Warranty Bulletin

**no. 82-1
REVISION 1**

Subject: Carburetor adaptor (P/N 570 1264 00)

no. 82-2

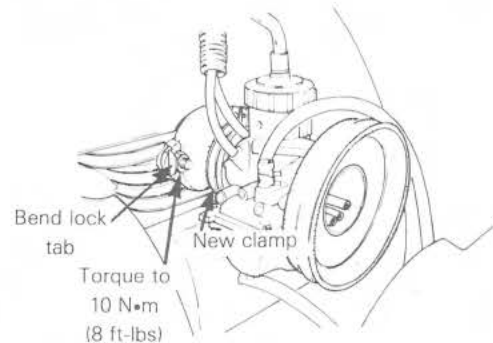
The carburetor adaptor may fail under certain conditions and may split due to vibration. (Refer to Warranty Bulletin 81-2).

Install a new carburetor adaptor (P/N 570 1264 00) using a clamp (P/N 404 1250 00) and two (2) studs M8 x 19.5 (P/N 420 940 170).

- Install the two (2) new studs (P/N 420 940 170) to the cylinder and torque to: 15 N•m (12 ft-lbs).

- Apply a thin layer of silicone sealant (P/N 747 002 000) on the new carburetor adaptor mating surface (P/N 570 1264 00).

- To secure the new carburetor adaptor, torque the two (2) retaining nuts to: 10 N•m (8 ft-lbs) and bend the two (2) lock tabs over a flat surface of the nuts.

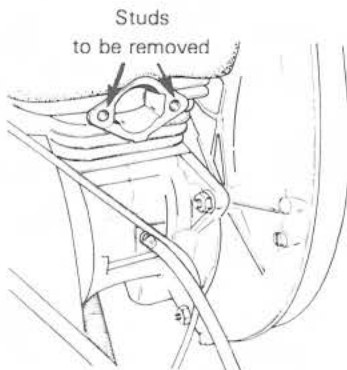
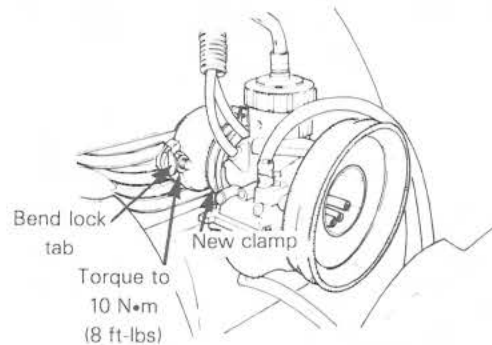
The carburetor adaptor may fail under certain conditions and may split due to vibration. (Refer to Warranty Bulletin 81-2).

Install a new carburetor adaptor (P/N 570 1264 00) using a clamp (P/N 404 1250 00) and two (2) studs M8 x 19.5 (P/N 420 940 170).

- Install the two (2) new studs (P/N 420 940 170) to the cylinder and torque to: 15 N•m (12 ft-lbs).

- Apply a thin layer of silicone sealant (P/N 747 002 000) on the new carburetor adaptor mating surface (P/N 570 1264 00).

- To secure the new carburetor adaptor, torque the two (2) retaining nuts to: 10 N•m (8 ft-lbs) and bend the two (2) lock tabs over a flat surface of the nuts.

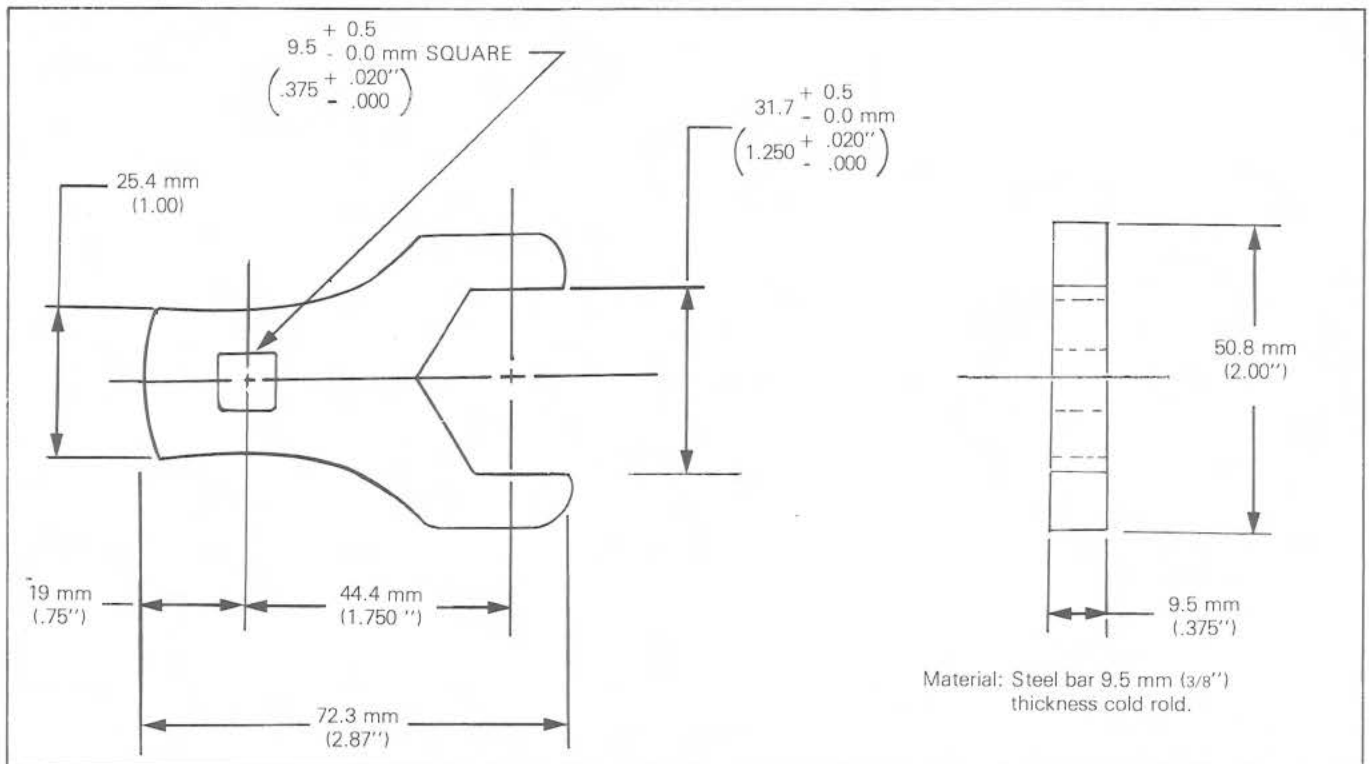
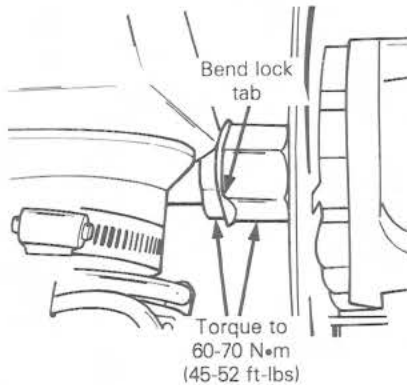
On the above mentioned vehicles, the countershaft/driven pulley retaining nuts were not properly torqued at assembly line. This will cause premature wear on drive belt.

You **must** torque the retaining nuts to 60-70 N•m (45-52 ft-lbs). This operation should be done at pre-delivery.

Make the following tool or use a Snap On extension key no. FC-40.

- Remove the air silencer.
- Unfold the retaining nuts lock tab.
- Loosen the nuts and verify pulleys alignment, adjust if necessary.
- Using the above mentioned tool, torque the retaining nuts to: 60-70 N•m (45-52 ft-lbs).

○ **NOTE:** For an accurate torque wrench reading you **MUST** use the following formulas:
